LATE REPRESENTATIONS SCHEDULE
PLANNING COMMITTEE – 8TH NOVEMBER 2017

PAGE NO. 178	APPLICATION NO: 17/01765/MJR
ADDRESS	225 ALBANY ROAD, ROATH, CARDIFF
FROM:	Geraldine Wright
SUMMARY:	<p>Dear Mr Clemence</p> <p>We would like to lodge our response to the planning committee report in light of the amended plans for the above planning application. We maintain our position and continue to strongly object to the application. We are dismayed that the case officer yet again recommends that permission be granted.</p> <p>I would like to point out the following mismanagement of the process following the last Planning Committee Meeting on 11th Oct 2017 and I would ask that you read the following statement to the committee when the case comes up for discussion. I will be addressing the committee once again and I DO NOT want to use my precious 3 minutes raising the issues of transparency and information communication.</p> <p>1. As per the Planning Committee minutes of the meeting on 11th Oct 2017: the application was deferred. Planning committee council members asked officers to draft reasons for refusal relation to KP5 and H5 of the LDP.</p> <p>2. As written in the new planning committee report

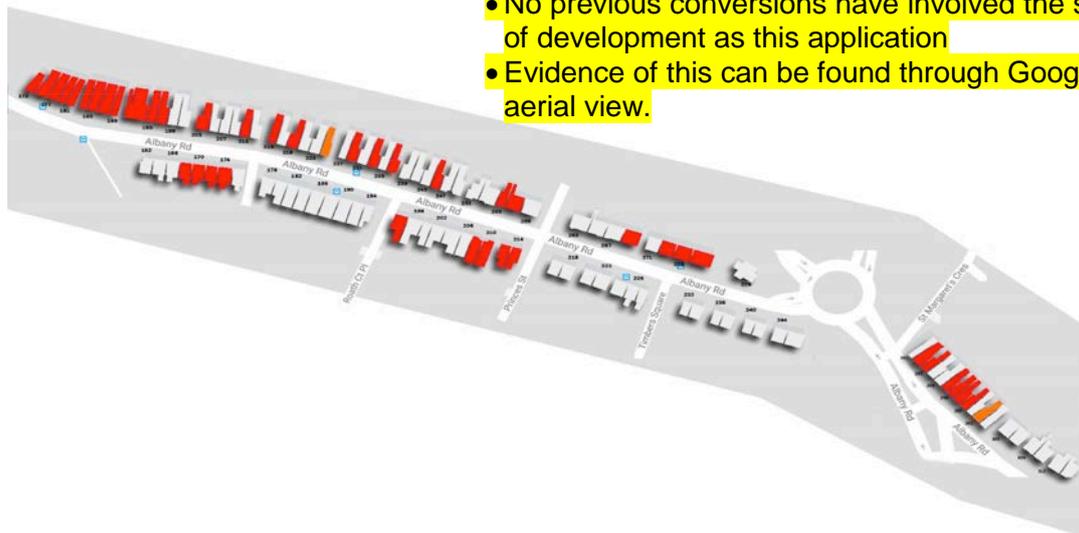
- The diagram below indicates the number of properties (**shown in RED**) already converted into flats. Results from our investigations demonstrate that 42% of houses in Albany Road are conversions

- None of these conversions encroach into the garden space, as does this application.
- Small dormer extensions are visible in only 4 properties on the Penylan ward side of the road
- No previous conversions have involved the scale of development as this application
- Evidence of this can be found through Google map aerial view.

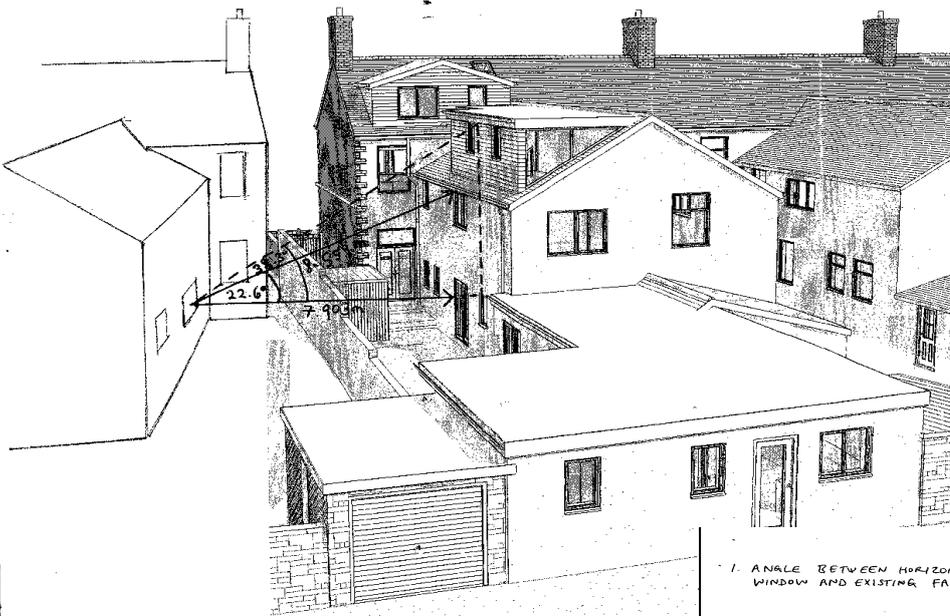
- The proposed addition of a huge dormer above Flat 4 will break this 25 degree rule. The occupants of the dining room, living room, kitchen (with dining facilities) and downstairs bathroom of 227 Albany Road will be adversely affected by this significant reduction in their access to daylight and sunlight and their view of the sky. These rooms are already deprived of light by virtue of their orientation and the tunnelling effect that the position of the annexes to these houses naturally produces; the dormer will compromise their daylight and sunlight further to an unacceptable extent.

- The 25-degree line projecting from the centre of the relevant window. In this case the scheme is acceptable by our own measurements the 25-degree line will be broken by the rear annex dormer extension as the diagrams below demonstrate:

Extension is an over-development of the plot

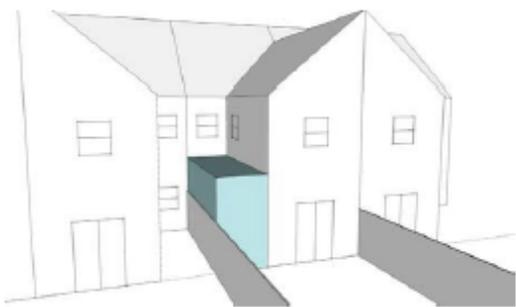
- *“For larger houses or those in areas where the establishment character includes good sized private gardens, any extensions or group of extensions/outbuildings beyond the permitted development limit, should ensure the retention of significant area of garden space. Proposals in this case will be considered in relation to character and context of the original house”*

- As pointed out already, much of the remaining external area is taken up with bin and cycle storage. The calculations above are incorrect 17.5m X 3.5m makes 61.25 m². Our calculations suggest 47m² is what remains therefore the scale of the single storey extension is **NOT** acceptable.
- The rear extension does not maintain a reasonable extension to back garden ratio resulting in an overdevelopment of the original garden area
- Many residents will feel the visual impact as the extension would be visible across a wide ranging landscape.

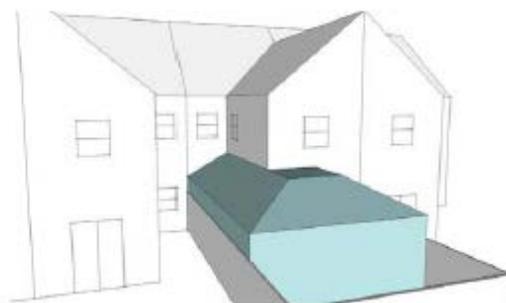
The height of the extension and position on the boundary is overbearing

Depth and height of extension is overbearing

- These diagrams help to illustrate the height of the wall of Flat 2 will overbear the neighbours in the garden of 223 Albany Road, resulting in the loss of the amenity of their garden. It will be 3 metres tall, very much higher than the existing stone garden wall. Their garden plants will be shadowed by the extra height running the entire length of the East side of the garden, and hit by water run-off from the extensive flat roof of Flat 2 at times of heavy rain.
